ECN/PCN No.: M1733

Product Description: 1200F HIGH CAPACITANCE SUPERCAPACITOR	Abraccon Part Number / Part Series: ADCS-E02R7SA128Q	☐ Documentation only ☒ ECN ☐ EOL	☐ Series ☒ Part Number(s)
Affected Revision: A	New Revision: B	Application:	☐ Safety ☒ Non-Safety

High Capacitance Supercapacitors

ADCS-E02R7S

Mechanical Specifications

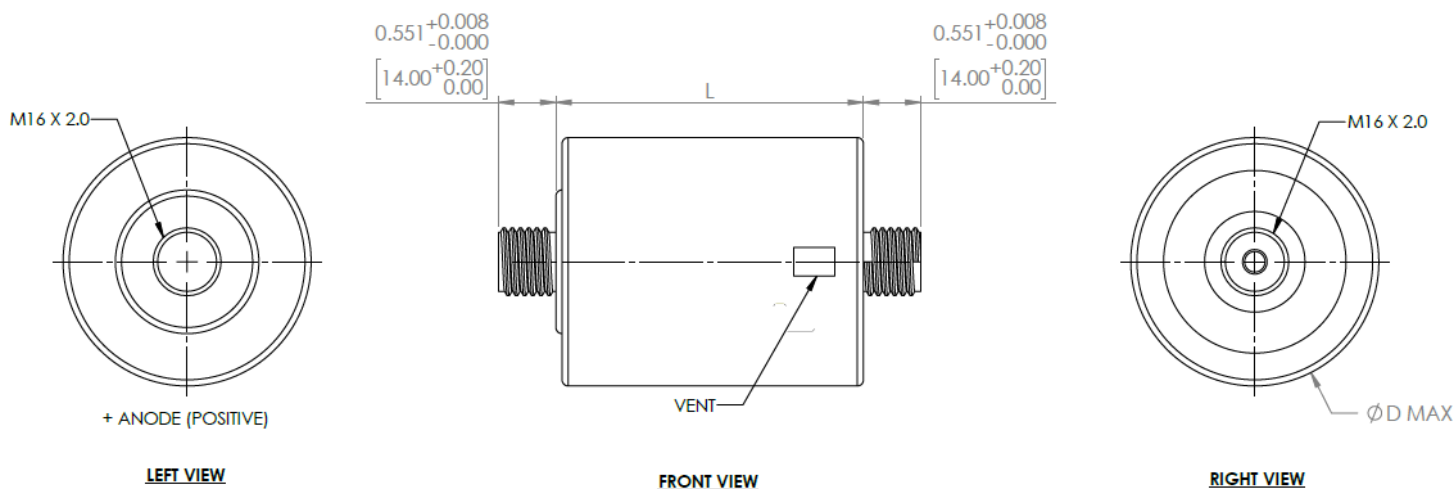
Updating mechanical specs and electrical specs

Small mechanical change may affect product fit. The minor electrical changes should not affect the products performance. Please carefully review.

Dimensions	ØD ±0.5	L ±0.5
ADCS-E02R7SA128	2.387[60.5]	2.913[74]
ADCS-E02R7SA158	2.387[60.5]	3.346[85]
ADCS-E02R7SA208	2.387[60.5]	4.133[105]
ADCS-E02R7SA308	2.387[60.5]	5.433[138]
